5 October 1980

EVALUATION OF DESIGN HAZARDS OF AIRBORNE ASH AND PYROCLASTIC FLOW FOR THE TROJAN POWER PLANT SITE.

Prepared for : Physicians for Social Responsibility (PSR)
SEARCH : 0312

FIGURE 2

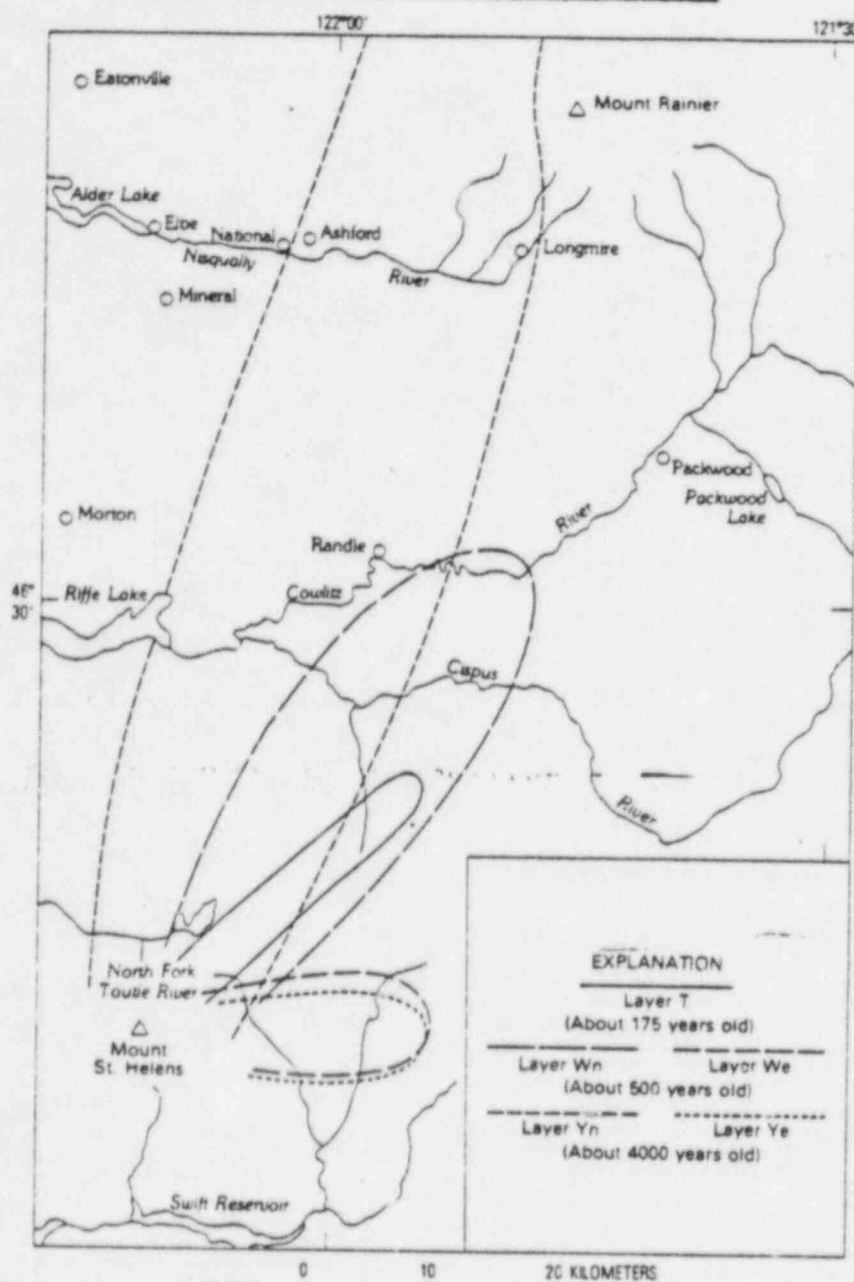
Five severe ash falls from Mount St. Helens are outlined in Fig. 2. Because of the strong winds present during the 18 May 1980 eruption, that ash fall was too thin and widely distributed to include in this map [Sarna-Wojcicki, Fig. 3 and p. 7 and Bull. 1383-C, p. C17]. Referring to Fig. 2, layer "Yn" is seen to be the most severe ash fall recorded. The compacted ash from that event is 3 feet deep 24 miles north of the volcano [Pumice and Pumicite Occurrences of Washington, State Div. of Mines and Geology Rept. No. 15, W. Carithers, 1945, p. 20] and 18 inches deep on Mt. Rainier 50 miles away [Mount St. Helens, The Volcano of Our Times, D. and D. Roberts, 1980, p. 4].

FIGURE 4

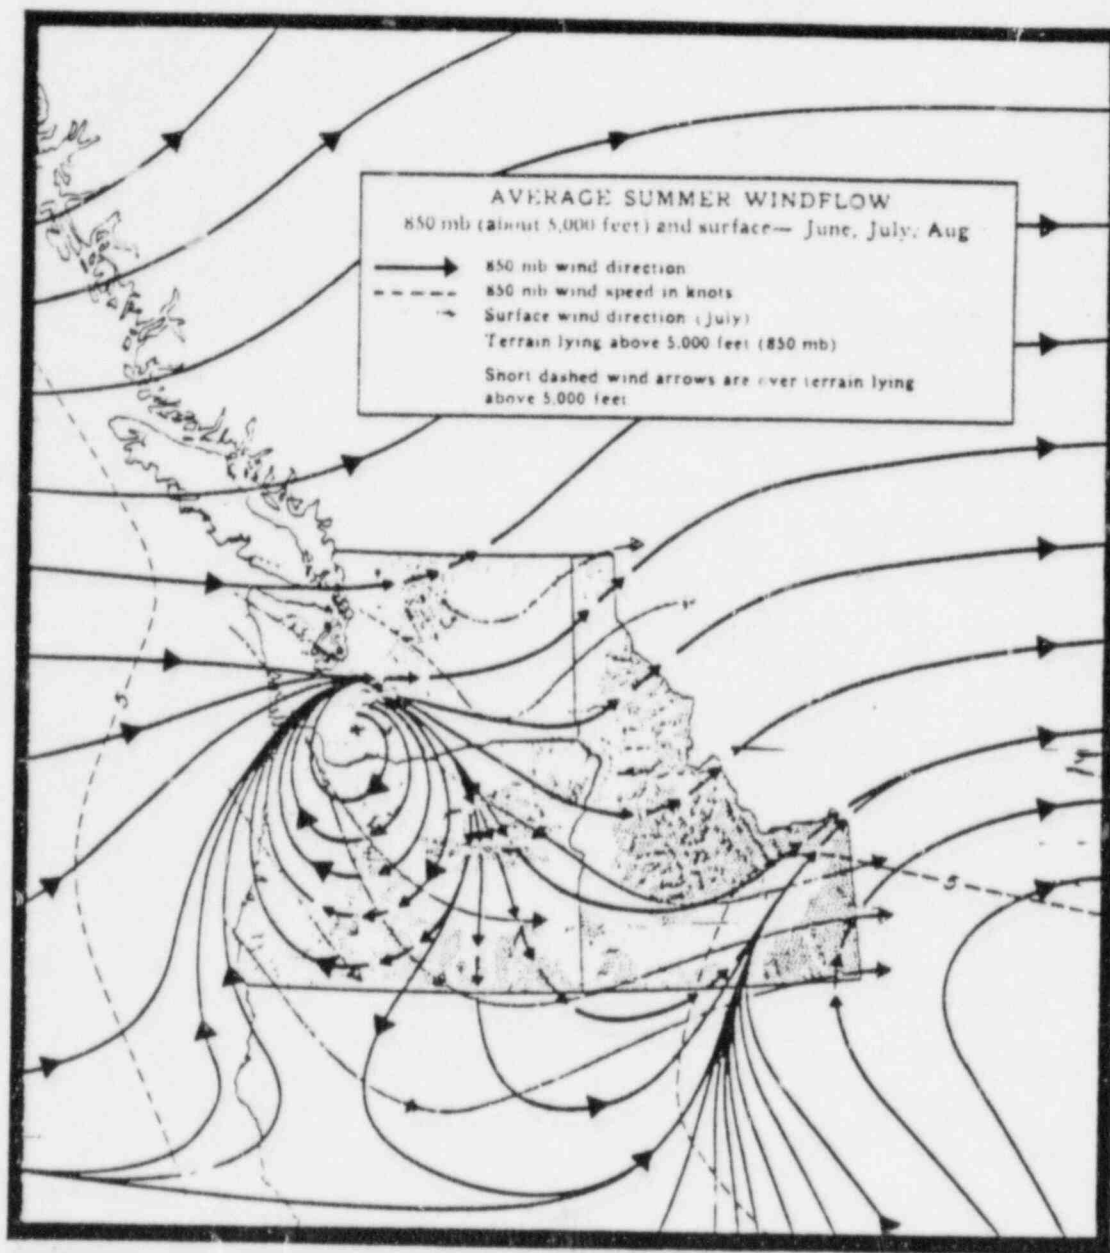
Similarly, wind speed and direction in the area must be considered to be variable. During the fall, winter and spring seasons, winds are dominantly toward the northeast. However, during the summer season,

~~Over extreme southwestern Washington and most of Oregon an anticyclonic cell, with sinking air-flow is found~~ [Atlas of the Pacific Northwest, 6th ed., R. M. Highsmith, Jr., and A.J. Kimmerling, eds., 1979, p. 45].

This is shown in Fig. 4. This wind pattern brought a sprinkling of ash to Portland and the Trojan site last summer, following very small eruptions of Mount St. Helens.

FIGURE 5 Shaded areas are for depths greater than 3-feet, 5-feet, and 10- feet.
Depth at Trojan site is about 8-feet, compacted ash.

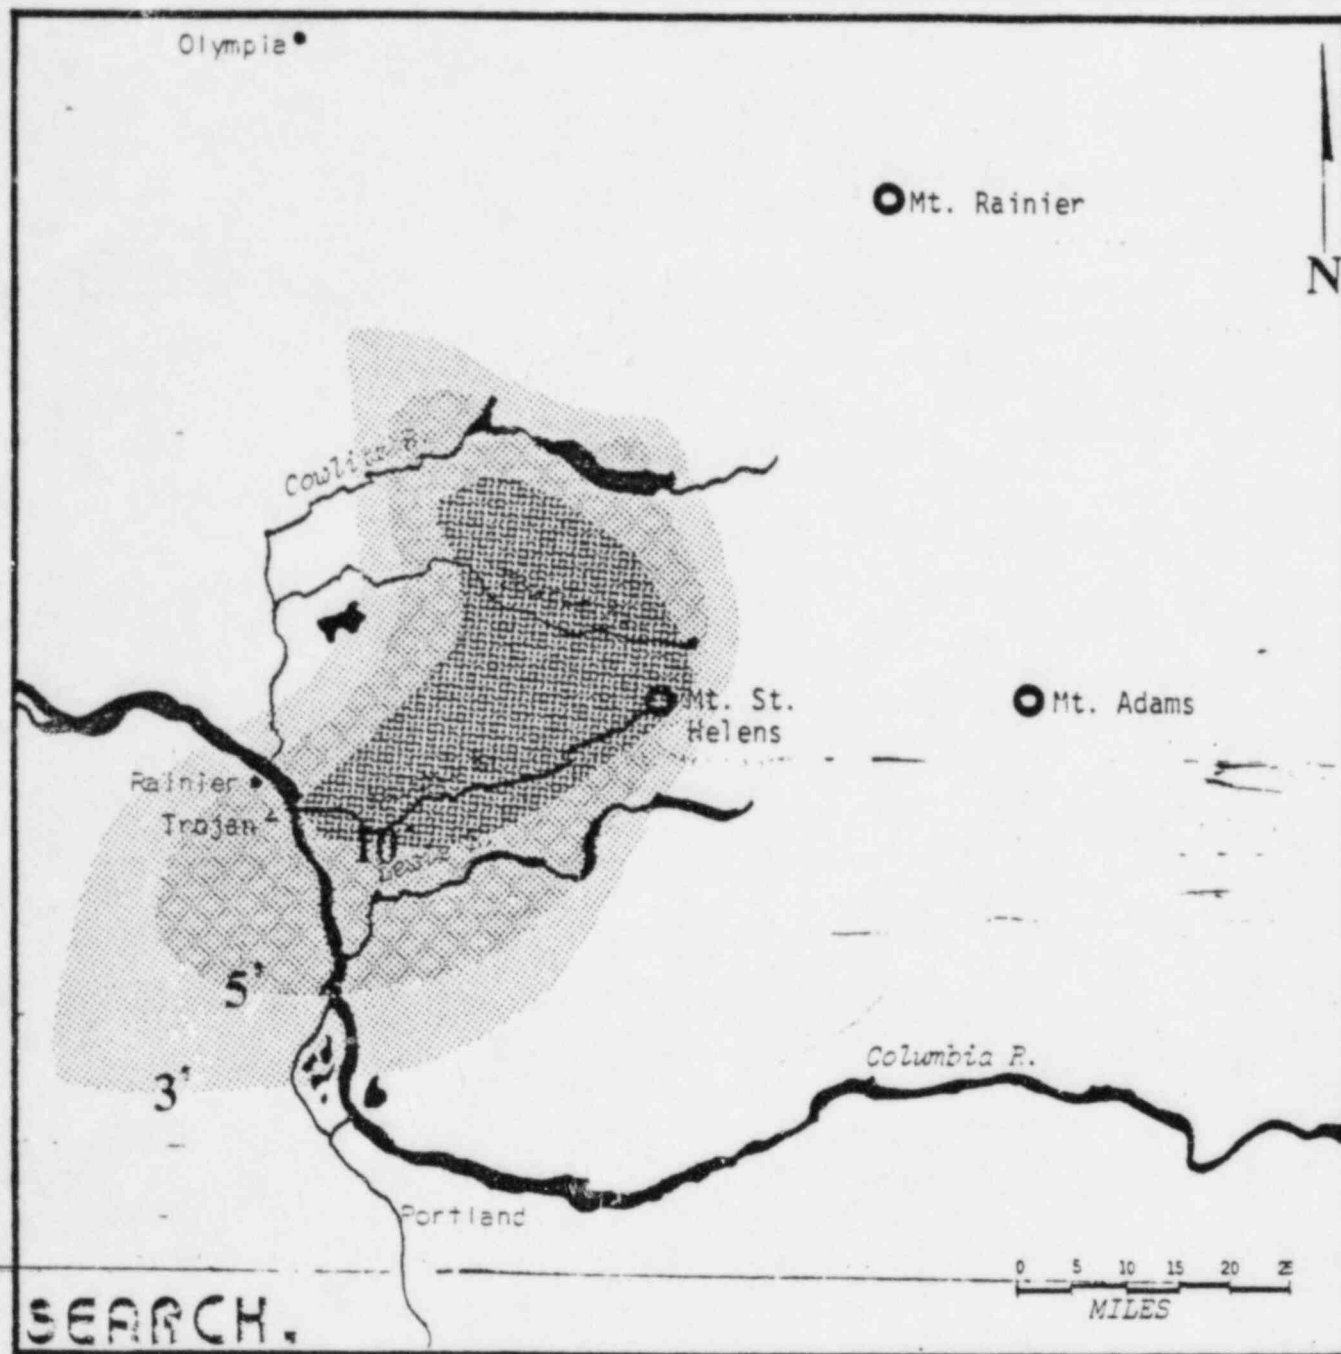
With this probability in mind, the Mt. Mazama eruption data can be superpositioned over Mount St. Helens, with the major lobe directed roughly toward the Trojan site, Fig. 5. This gives an idea of the potential ash fall at site from a severe eruption of Mount St. Helens. The result: About 8 feet of compacted ash at site. The initial fall of uncompacted ash would probably be at least twice this deep--16 feet.

From the above considerations, the present risk of a Mt. Mazama-class ash eruption from Mount St. Helens is proposed to be about one in 10,000 per year--roughly the length of record. With an estimated 20 percent chance of this deposition being directed toward site, the risk of an uncompacted ash fall of 16 feet at Trojan site is estimated to be one in 50,000 per year.

- [1] Trojan site should probably have design depths for ash fall in excess of 16 feet for fresh, dry ash or 8 feet of wet ash. This design depth applies directly to design loading of structures and indirectly to plant operations and functions.
- [2] Pyroclastic flows should probably be included as a plant design condition. This design condition implies criteria of temperature, wind, erosion and impact, and loading. These criteria apply to structures and to plant operations and functions.
- [3] The Trojan Final Safety Analysis shows no comprehension of the analysis or design required to assure safe plant operation. Thus, there is no apparent, present basis to assure safe operation of the facility.
